**Project #15-042
777 Subdivision
Located at 777 North 700 East**

Project Name: 777 Subdivision
Proponent / Owner: Steve Earl / K. Erik Daines
Project Address: 777 North 700 East
Request: 7 Lot Subdivision
Current Zoning: Campus Residential (CR)
Type of Action: Quasi-Judicial
Hearing Date: August 27, 2015
Submitted By: Amber Reeder, Planner II

PRELIMINARY PLAT
777 SUBDIVISION
PART OF SE 1/4 OF SECTION 27, TOWNSHIP 12 NORTH,
RANGE 1 EAST, SALT LAKE MERIDIAN
ALSO PART OF LOTS 7 & 8, BLOCK 4, PLAT "E", LOGAN CITY SURVEY
LOGAN CITY, CACHE COUNTY, UTAH

PRELIMINARY PLAT

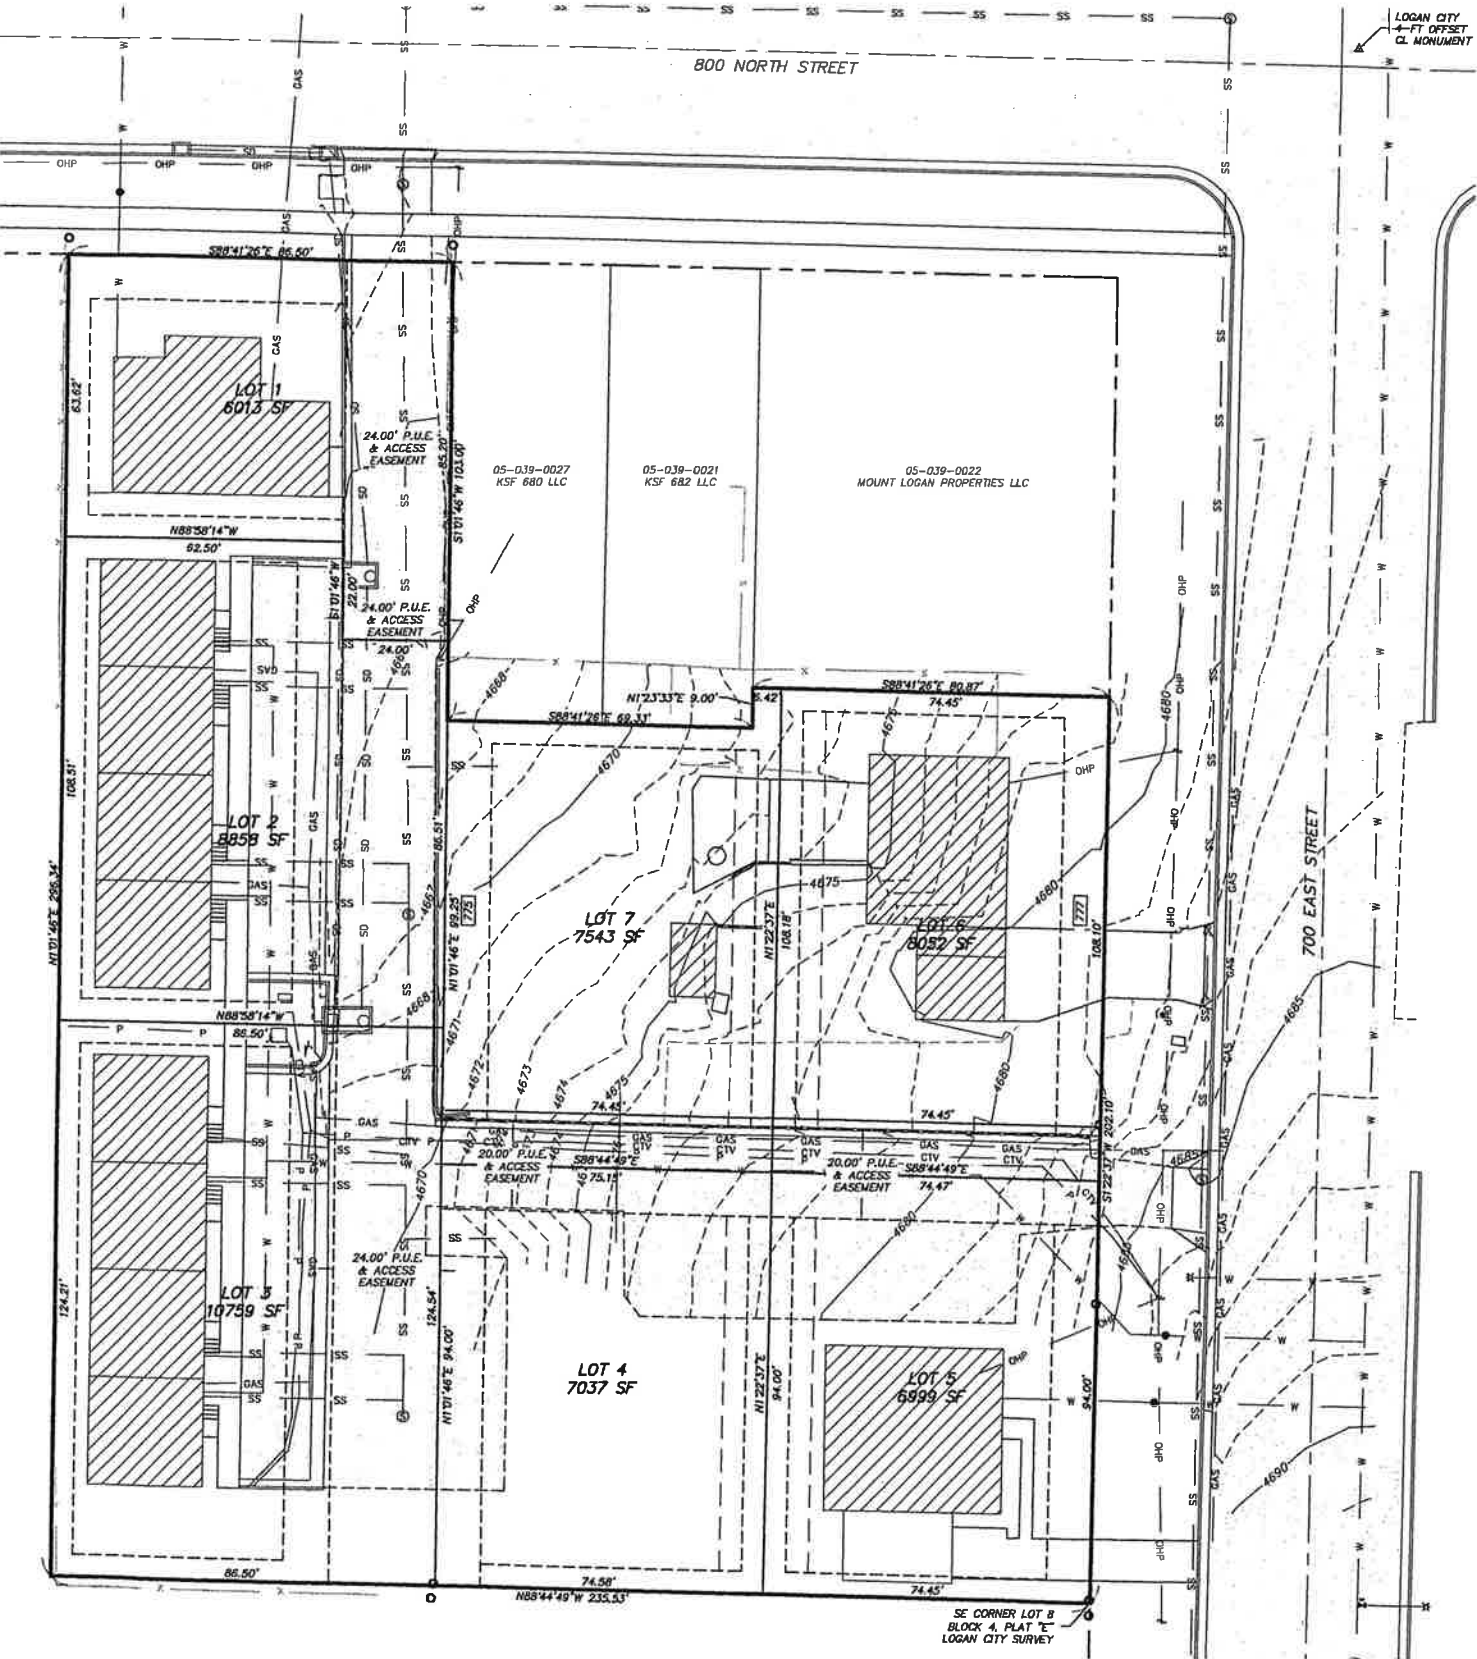
A minimum lot size of 6,000 sq ft is required. All lots meet the minimum size and density. Lot 1 is 6,013 sq ft and if the lot line between Lot 1 and Lot 2 is adjusted to the north to meet setbacks it would need to be adjusted in the access drive to ensure the lot size is a minimum of 6,000 sq ft. As conditioned, the subdivision is compliant with the LDC.

The property line proposed between Lot 1 and Lot 2 is not in compliance with the Land Development Code (LDC). The proposed line only provides for a 5' side yard setback on Lot 2. The plat incorrectly lists the side yard setback requirement as 5'. Should the Commission consider the 7.5' side yard setback acceptable, staff recommends that the lot line between Lot 1 and Lot 2 be adjusted to a 7.5' setback between the buildings. This would allow the setback to be in substantial compliance and be allowed. Otherwise, a lot line would not be allowed between the buildings and the duplex at 668 East 800 North and the north 4-plex will need to remain on the same lot. The owner could also apply for a consideration of a variance.

The project is not proposing any changes to accesses. The City Engineer recommends the curb cut and access drive off of 700 East be widened to a minimum of 20' to allow for emergency vehicle access. A minimum 20' wide access is required to meet requirements for emergency vehicles such as fire trucks.

The residence at 777 North 700 East is an existing residence with space for 2 cars in the carport and 2 cars in the driveway. Area to the south of the house is being used for parking. This area is not improved and includes parking in the front setback. Parking in this area needs to be discontinued or improved with a concrete or asphalt surface. The parking area must be to the side or rear of the building so it cannot extend in front of the front plane of the home. If this area is intended for further use as parking, it will need to be indicated on construction drawings for the subdivision so that it can be reviewed to ensure compliance with parking location, dimension, and landscape requirements.

Lot 2 provides 26% of the lot area as land set aside space. Should the lot line between Lot 1 and Lot 2 be adjusted to meet setbacks, this will increase the percentage on Lot 2 to approximately 28% and Lot 1 will still be at approximately 40%. Lot 2 can be considered by the Planning Commission to be in substantial compliance at 28%.

- Lot 5 may be required to maintain the minimum requirement of the Conditional Use permit and be adjusted to accommodate 3696 sq ft of landscaping and open space. The lot line between Lot 4 and Lot 5 could be adjusted to provide additional open space to Lot 5. Lot 4 could not be adjusted to less than the minimum lot size of 6,000 sq ft.

- i. Existing dumpster size and location adequate. New construction can share existing dumpsters.
 - c. Engineering:
 - i. PUE & Access Easement recommended to be a minimum of 24' between Lots 4-7 if vehicles are to continue backing from 90 degree parking stalls as done currently.

- x. Current access to 700 East is approximately 16', may need to widen to 20-22 feet for emergency vehicle access. Address in subdivision construction drawings or with a work in right-of-way permit.

3. A side yard setback of 7.5' between buildings on Lot 2 and Lot 3 are considered in substantial compliance with the CR standards.
4. The lot line between the buildings on Lot 1 and Lot 2 be adjusted to 7.5' from either building. The lot size of Lot 1 must be a minimum of 6,000 square feet.

6. Parking on the south side of the 777 North 700 East residence will be discontinued or be reviewed and developed in accordance with standards in the LDC for location, dimensions, and landscaping.

- a. Fire Department:
 - i. Designate which drive will be for fire apparatus access. Fire apparatus access shall be 20 ft wide at all points with a minimum 12' 6" height. If the access is longer than 150 ft then an approved turnaround is required.

- ii. Provide storm water detention/retention to meet current City design standards for entire site (subdivision).
 - iii. Construct sidewalk along frontage on 700 East. Contact Engineering to determine location and layout as grades may require retaining walls or other grade separation structures to accomplish.
